APPLICATION NO.	FILING DATE	FIRST NAMED INVENTOR	ATTORNEY DOCKET NO.	CONFIRMATION NO.
10/038,805	12/31/2001	Robert L. Popp	KCC 4773 (K.C. No. 17,181)	2929
321	7590	12/23/2004	EXAMINER	
SENNIGER POWERS LEAVITT AND ROEDEL ONE METROPOLITAN SQUARE 16TH FLOOR ST LOUIS, MO 63102			BOGART, MICHAEL G	
			ART UNIT	PAPER NUMBER
			3761

Office Action Summary	Application No. 10/038,805	Applicant(s) POPP ET AL.	
	Examiner Michael G. Bogart	Art Unit 3761

DETAILED ACTION

Fig. 7

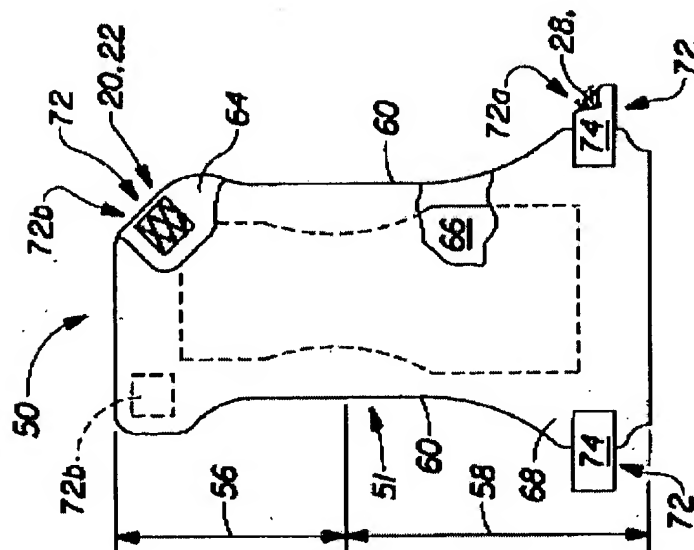
a hook fastening component (72a) disposed in the second end region (58) of the garment body (51) and comprising a hook material (24, 28) adapted to refastenably engage the multi-directional stretchable loop fastening component (22, 72b)(figure 7, below)(column 17, lines 13-27).

Regarding the limitation that the loop fastening component (22, 72b) is extensible in use in first and second perpendicular directions and elastomeric in at least one of these

directions, Allen *et al.* teach that the combined laminate (22) of elastic (34) and loop material (30) is elastically extensible in at least the machine and cross-machine directions which are within the plane of the material and which are perpendicular to each other (column 17, lines 13-27).

Regarding claims 28 and 29, Allen *et al.* teach a liquid pervious inner layer (64), an opposed outer layer (68), and an absorbent layer (66) therebetween (figure 7).

Regarding claims 16 and 25, Allen *et al.* teach that the loop fastening component (72b) comprises side panels of the body (51)(see figure 7, above).
